# CITY OF ALBUQUERQUE

Site: Ascension Subdivision – 8814 Horizon - B17E006

**Re: Drainage Ordinance (14-5-2-1) Violations for Erosion and Sediment Control**

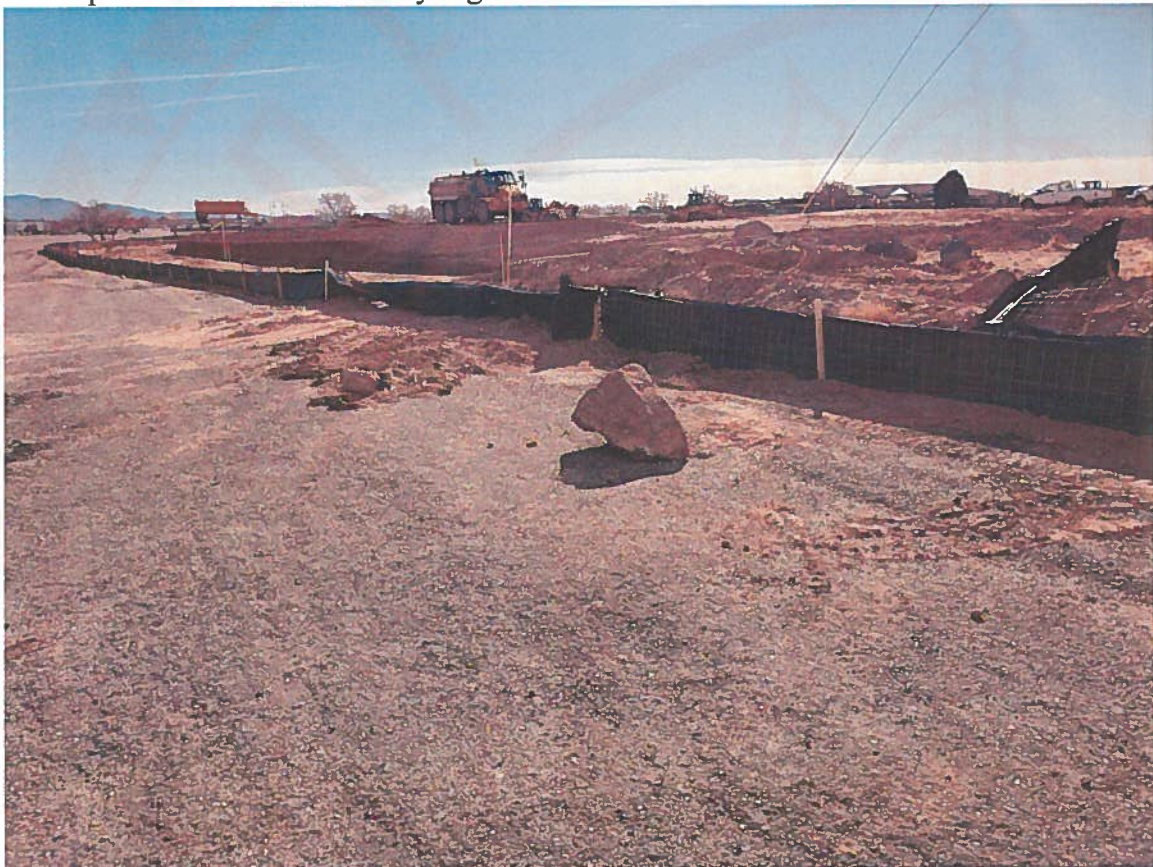
1. The east silt fence has a hole near the north end and sediment offsite there and near the southeast corner in the vicinity of the offsite curb and inlets.
2. Track-out at the north entrance.

These photos were taken two days ago:

1. Initiate maintain of stormwater controls immediately upon identification of the need and complete such work by the end of the next business day.
2. Implement additional track-out controls to insure that sediment is removal occurs prior to vehicle exit.
3. Where sediment has been tracked-out onto paved areas outside your site remove and dispose of sediment by the end of the same business day.
